ORNL Evaluation of Electrabel Safety Cases for Doel 3 / Tihange 2: Final Report (R2)

November 2015

**ORNL EVALUATION OF ELECTRABEL SAFETY CASES
FOR DOEL 3 / TIHANGE 2: FINAL REPORT (R2)**

Fig. C.4 Assessment of individual flaw 1660 found in Tihange 2 and subjected to the postulated LOCA 1; flaw is non-compliant according to ASME acceptance criteria with or without WPS.

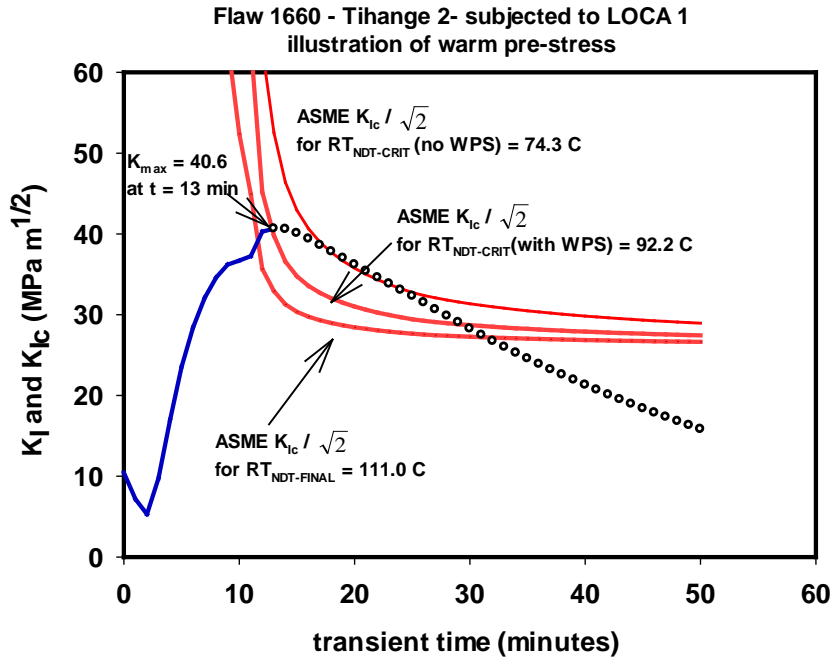
Figure C.4 illustrates that inclusion of WPS in the assessment of individual flaw 1660, found in Tihange 2 and subjected to LOCA 1 (Appendix B), decreases $RT_{NDT-FINAL}/RT_{NDT-CRIT}$ from 1.49 to 1.20; thus, flaw 1660 remains non-compliant according to ASME acceptance criterion with or without WPS.
